The Commission has issued the enclosed Amendment No. 37 to Facility Operating License No. NPF-2 and Amendment No. 27 to NPF-8 for the Joseph M. Farley Nuclear Plant, Unit Nos. 1 and 2, respectively. The amendments consist of changes to the Technical Specifications in response to your application dated October 13, 1983.

JOSEPH M. FARLEY NUCLEAR PLANT, UNIT NO. 1

Amendment No. 37
License No. NPF-2

SAFETY EVALUATION BY THE OFFICE OF NUCLEAR REACTOR REGULATION
RELATED TO AMENDMENT NO. 37 TO FACILITY OPERATING LICENSE NO. NPF-2
AND AMENDMENT NO. 27 TO FACILITY OPERATING LICENSE NO. NPF-8

Figure 2.1-1 Reactor Core Safety Limit
Three Loops in Operation

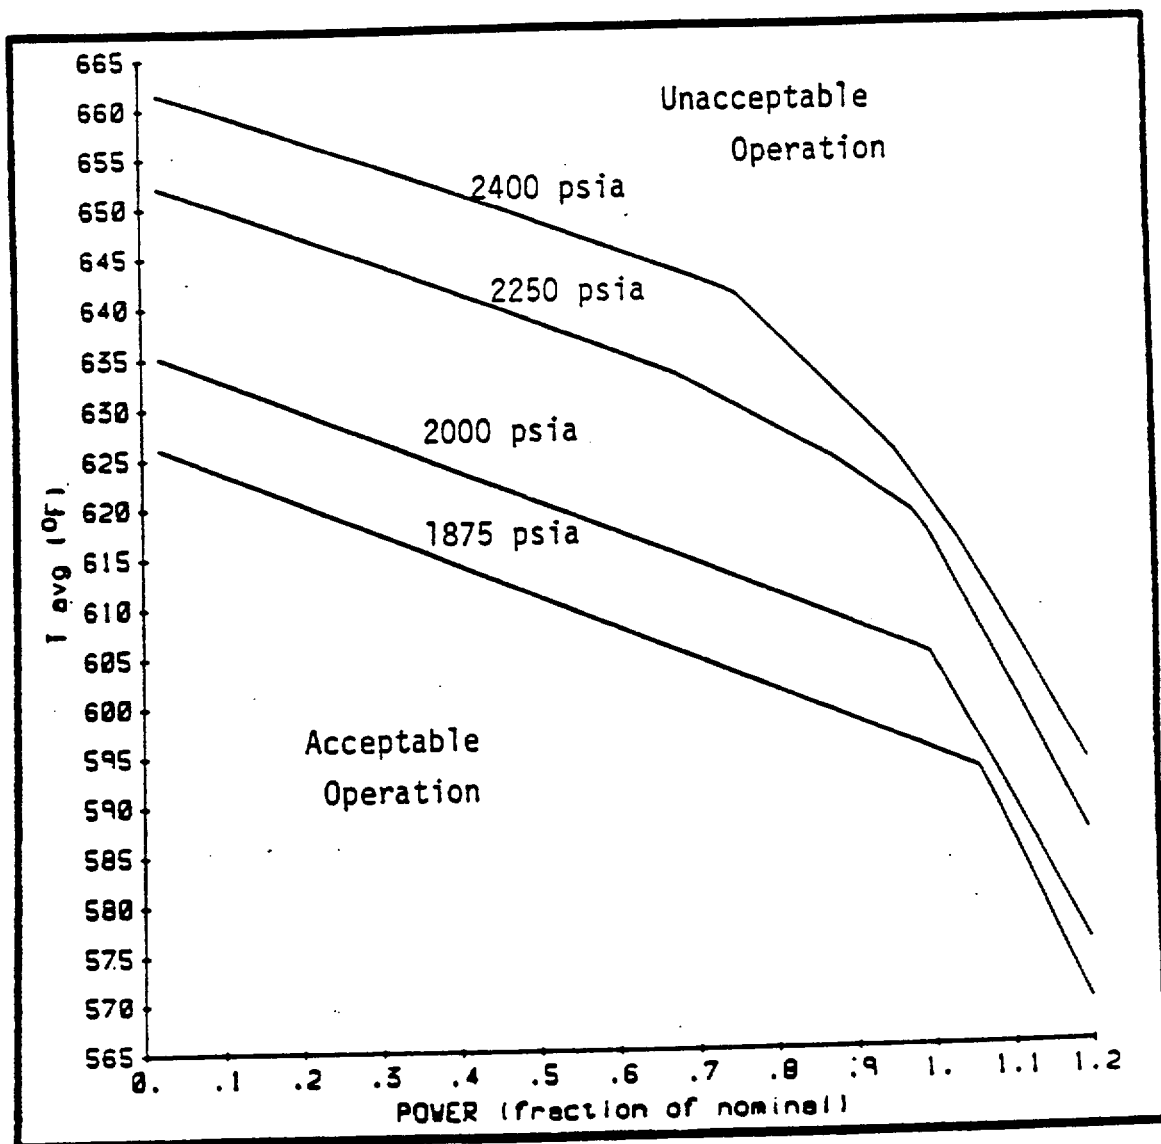
- (3) The overpower and overtemperature ΔT setpoints defined in Specification Table 2.2-1 were revised in order to optimize the available operational margin that exists between the setpoints and the new core safety limits (Figure 2.1-1) which were established due to the above-mentioned $F_{\Delta H}^N$ change. The constants in these ΔT setpoints were modified according to the setpoint methodology accepted for all previous Westinghouse cores and described in WCAP-8745, "Design Bases for the Thermal Overpower ΔT and Thermal Overtemperature ΔT Trip Functions." Those incidents which rely on these trips were reanalyzed to confirm that the limiting conditions and safety criteria are met. Therefore, the revised overpower and overtemperature ΔT protection setpoint modifications are acceptable.
